07DM 09.5-3002/1

REF. PLAN	GEOLOGY	SCALE 1: 250	
	SURVEY		
	PLANNING	MR 12 JAN 82	N62 220 r1. FOOTWALL. ADDITIONAL CABLES TO COMPENSATE FOR MISSING HANGING WALL CABLES
	ROCK MEC.		
	GRADE CON.		
	DRAFTING		
	T.S.S.		DRAWING NUMBER
			07DM 09.5-3002/1

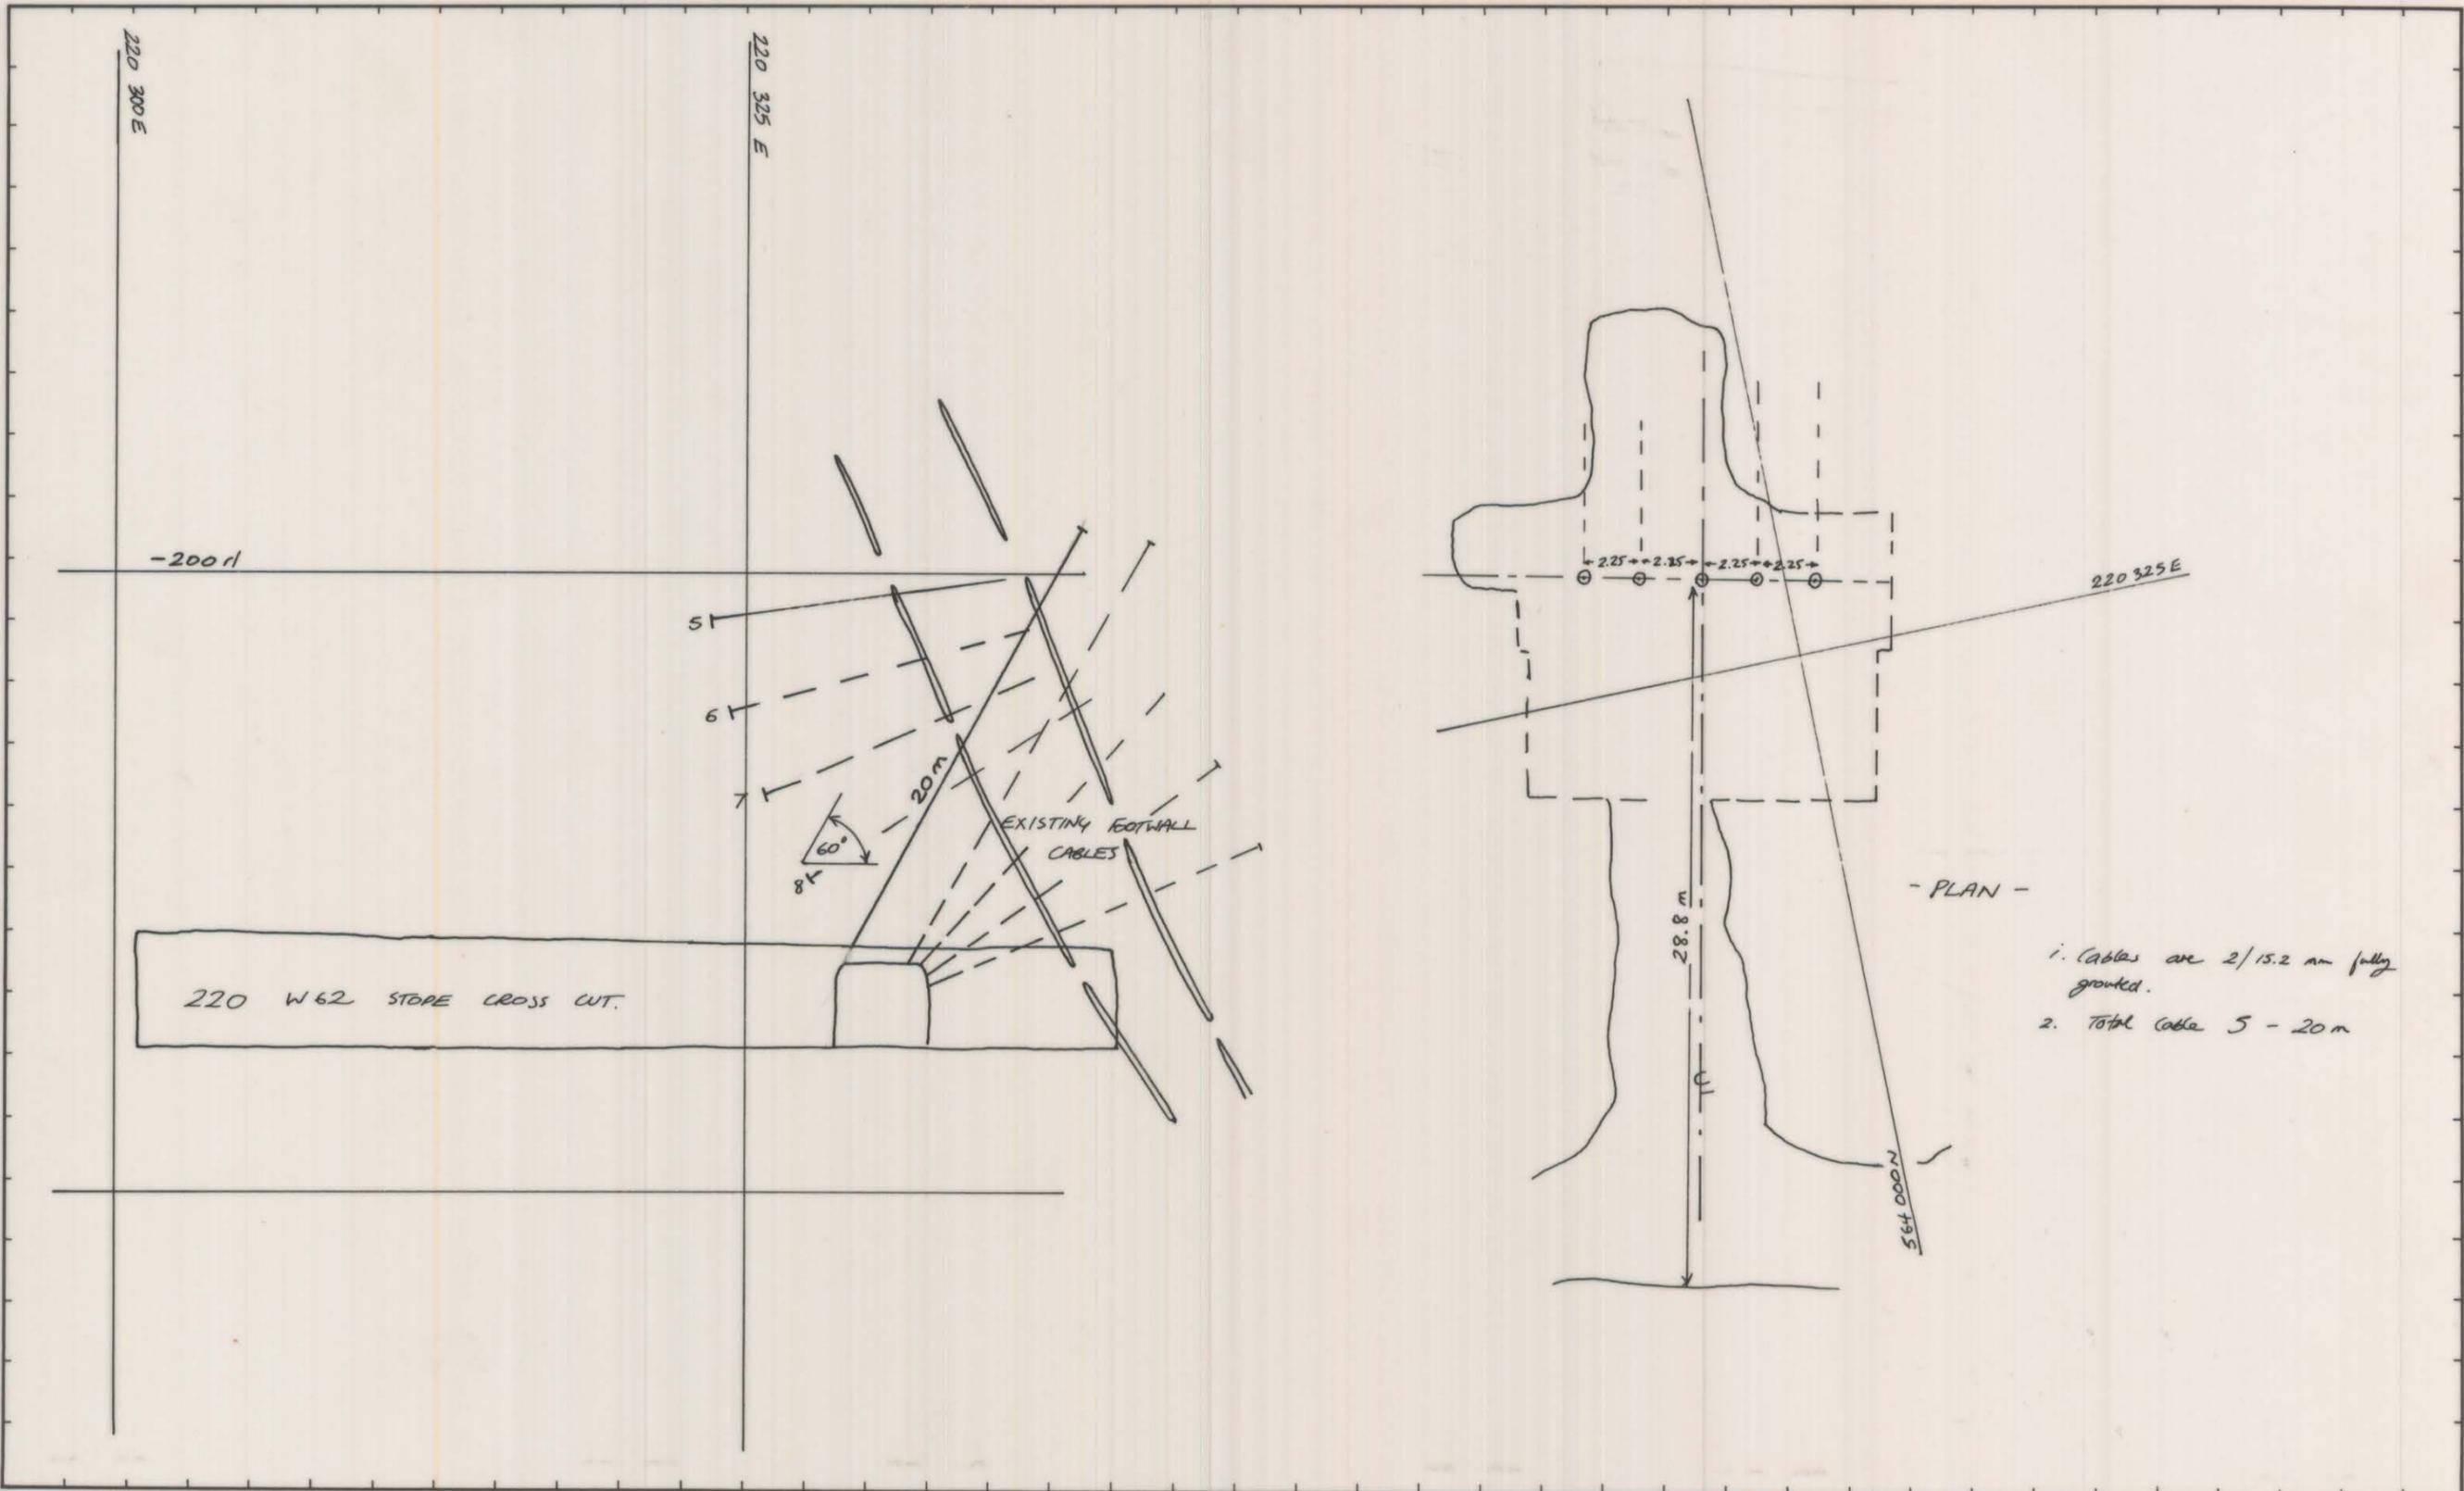
Note: THESE CABLES ARE TO COMPENSATE FOR CABLE N°9 MISSING FROM RINGS A, B, E, G + H? ON THE HANGING WALL SIDE.

- 1. Cables are 2/15.2 mm fully grouted.
- 2. Total cable 5 - 20 m
